Docket Item #5A-D

Development Special Use Permit #2011-0015

<u>Application</u>	<u>General Data</u>	
<u>Project Name:</u> Safeway on King Street	PC Hearing:	November 1, 2011 December 6, 2011
	CC Hearing:	November 12, 2011 December 17, 2011
	If approved, DSUP Expiration:	December 17, 2014 (three years)
<u>Location:</u> 3526 King Street	Zone:	Existing: CG/Commercial General Proposed: OC/Office Commercial with proffer
	Proposed Use:	Retail
<u>Applicant:</u> Safeway, Inc., represented by Duncan Blair	Small Area Plan:	Fairlington/Bradlee
	Historic District:	Not Applicable
	Green Building:	LEED Silver Certification for New Construction

MPA#2011-0007, REZ#2011-0002
DSUP#2011-0015, TMP SUP#2011-0060
Safeway, Inc., 3526 King Street

Existing Map 3 in Fairlington/Bradlee Small Area Plan

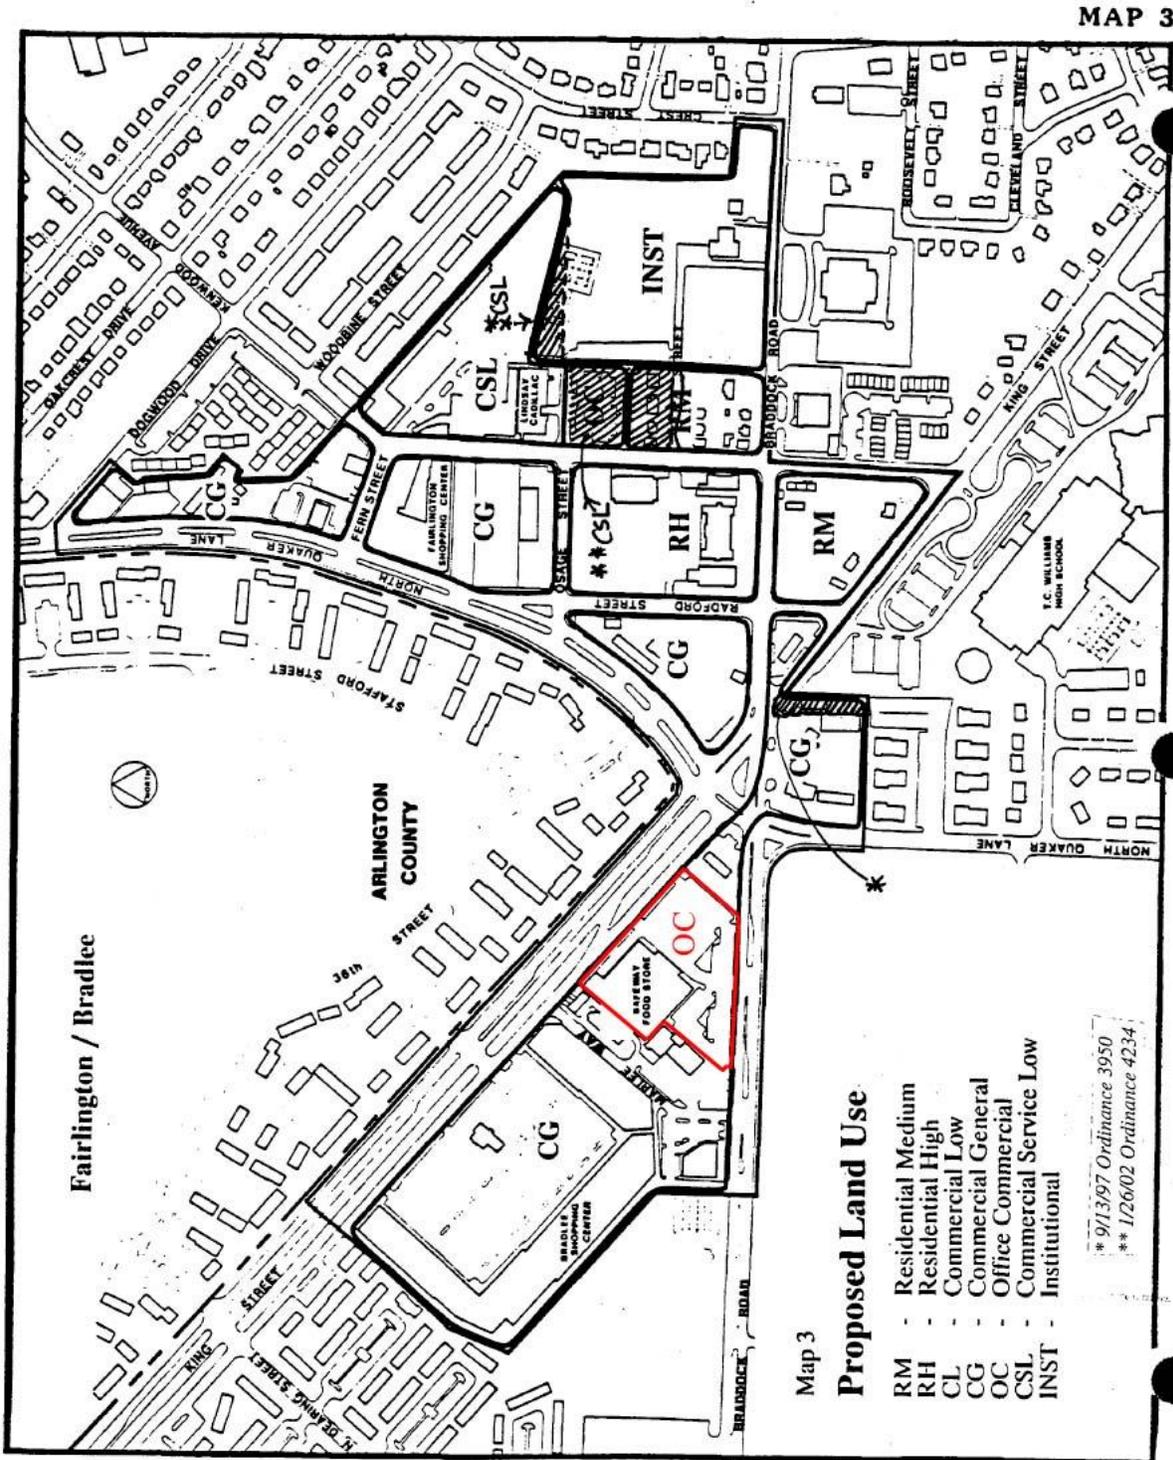
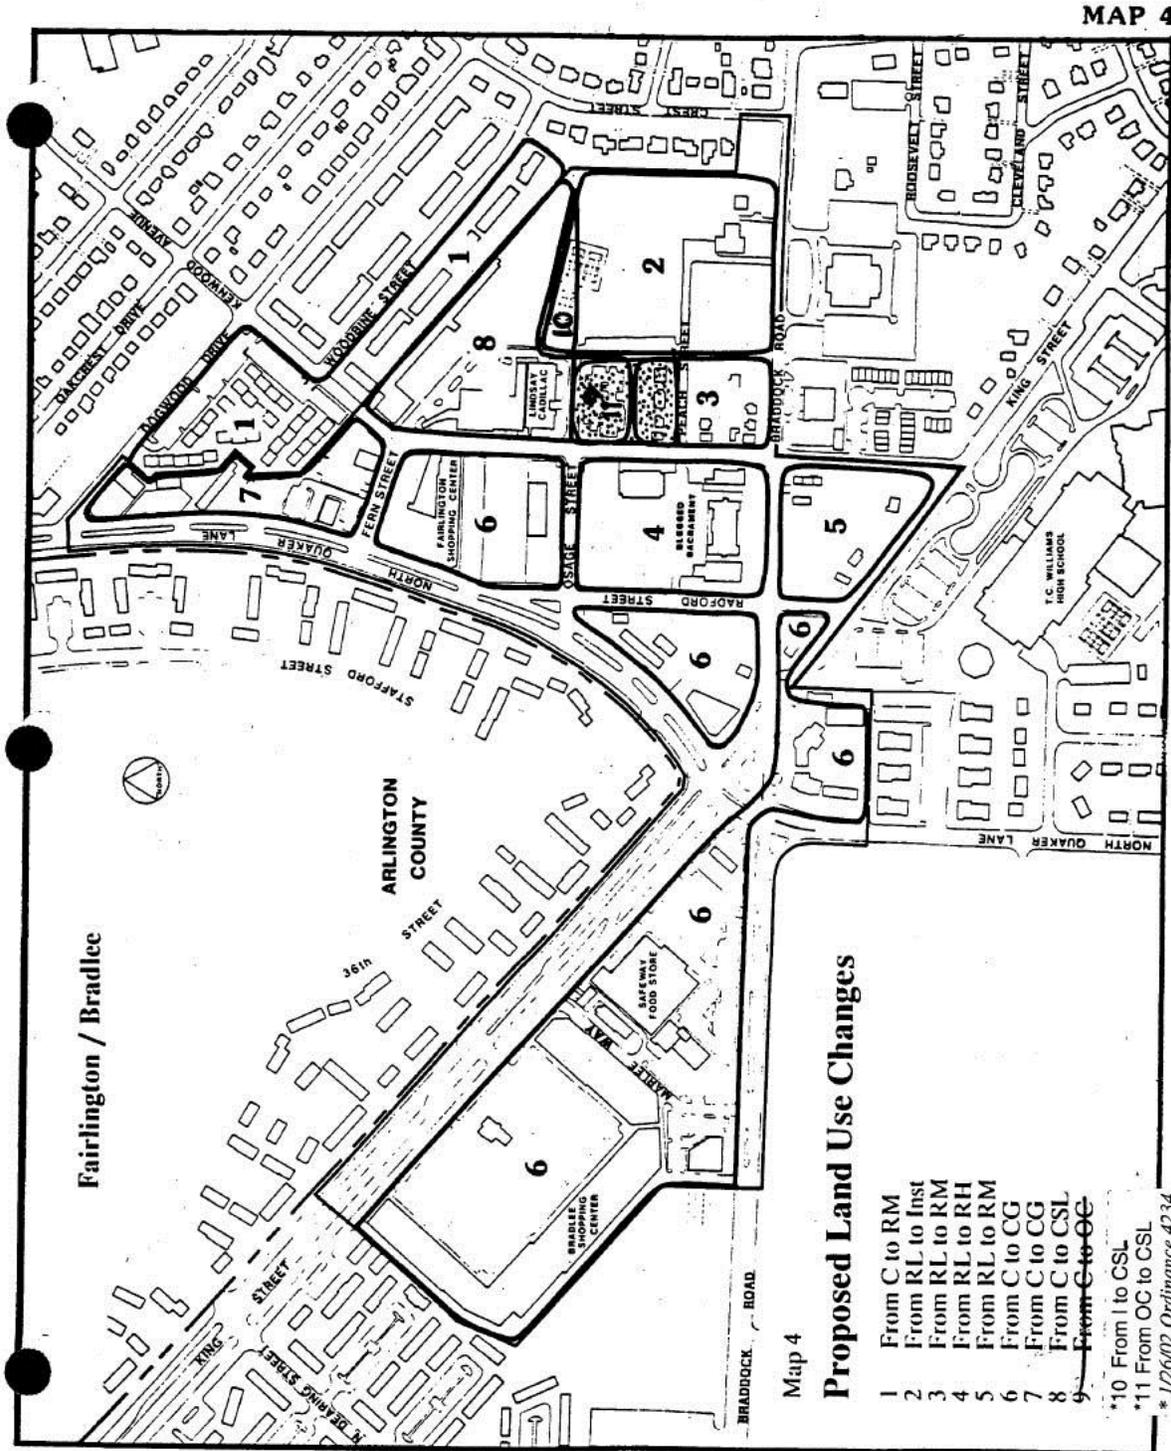
The applicant is requesting an amendment to the Fairlington/Bradlee Small Area Plan chapter of the City's Master Plan in order to change the land use classification from the Commercial General (CG) zone to the Office Commercial (OC) zone, and to amend the maps in the small area plan to show this change.
